There are some typos in the claimant's SF-4 (amended claim):

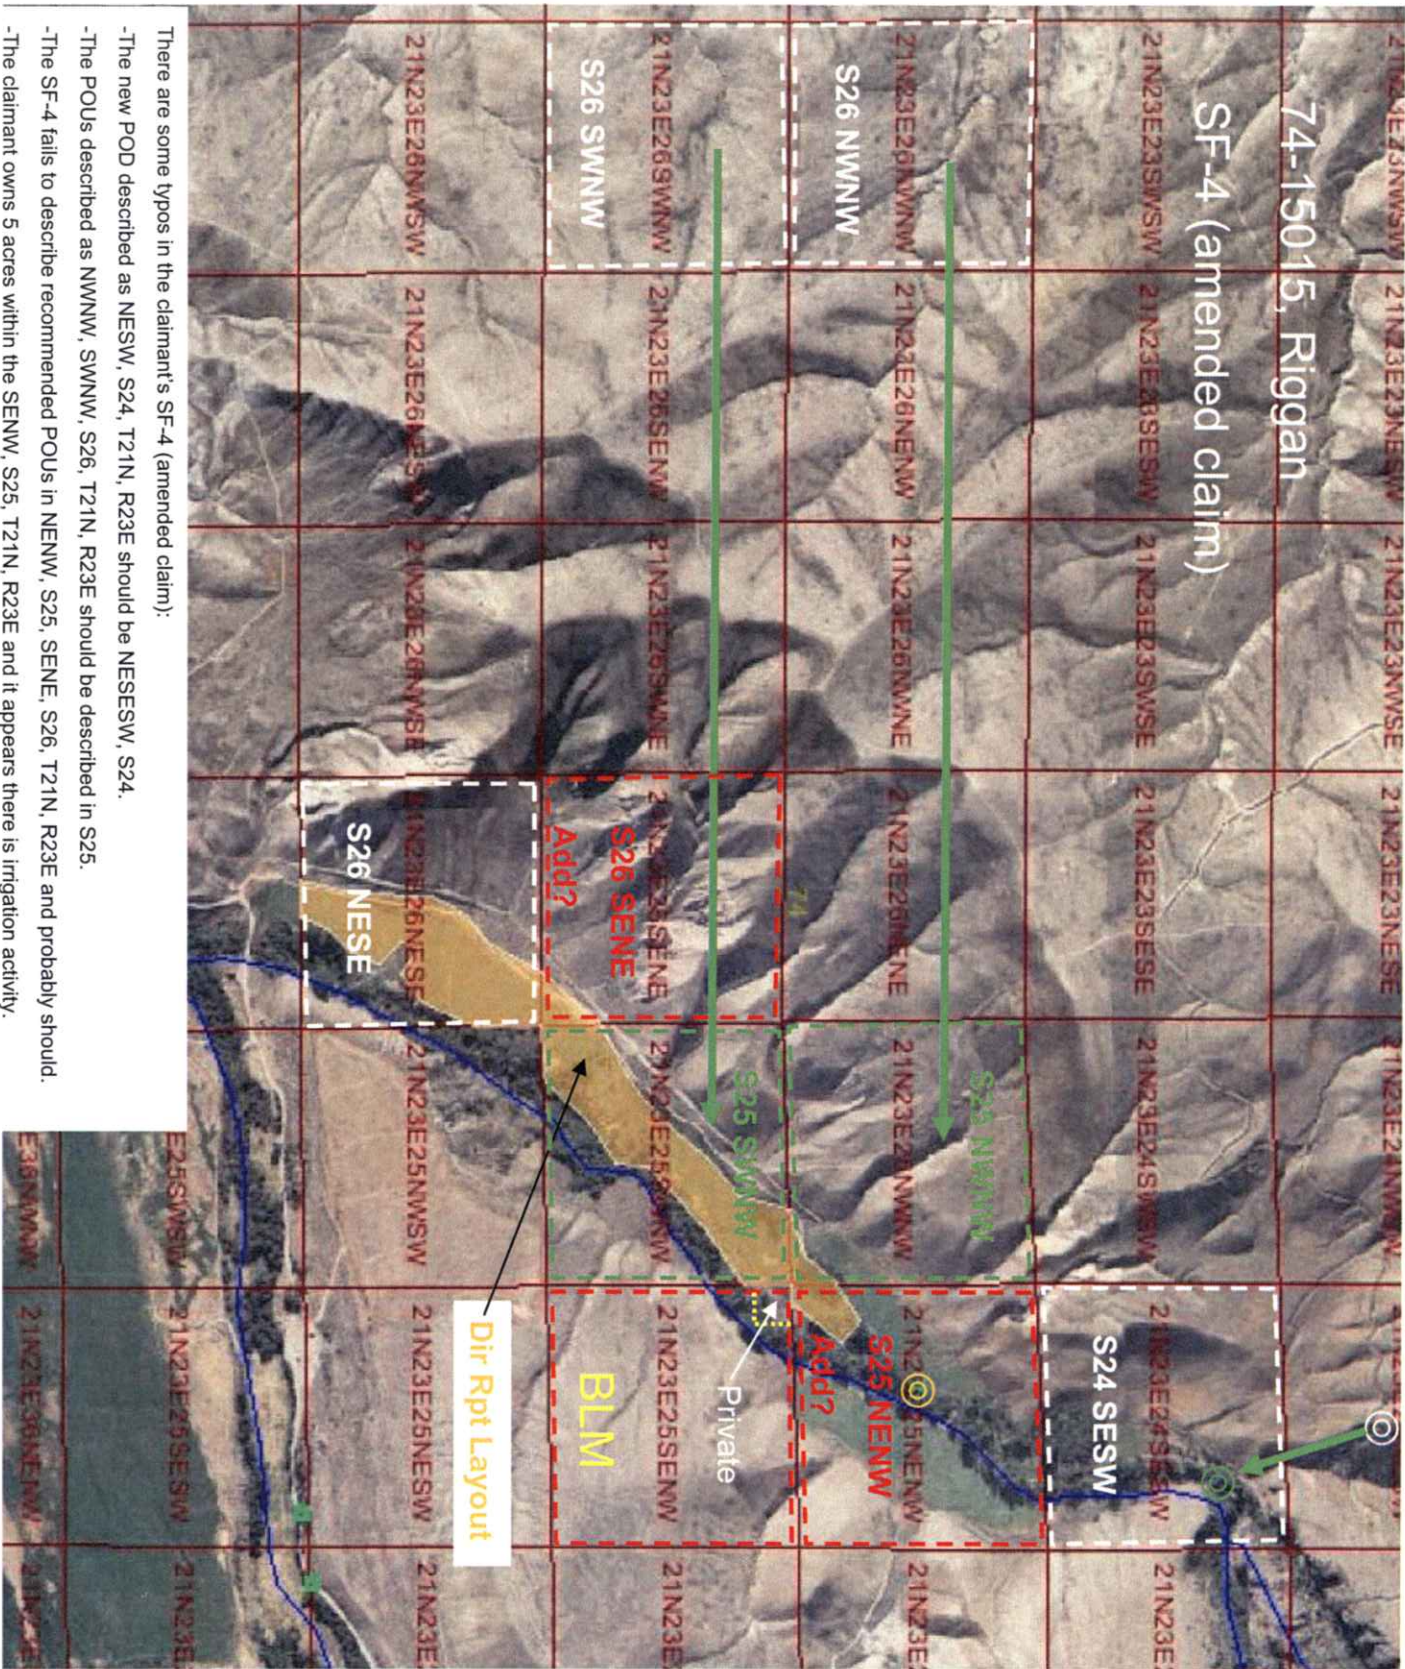
- The new POD described as NESW, S24, T21N, R23E should be NESESW, S24.
- The POUs described as NWNW, SWNW, S26, T21N, R23E should be described in S25.
- The SF-4 fails to describe recommended POUs in NENW, S25, SENE, S26, T21N, R23E and probably should.
- The claimant owns 5 acres within the SENW, S25, T21N, R23E and it appears there is irrigation activity.
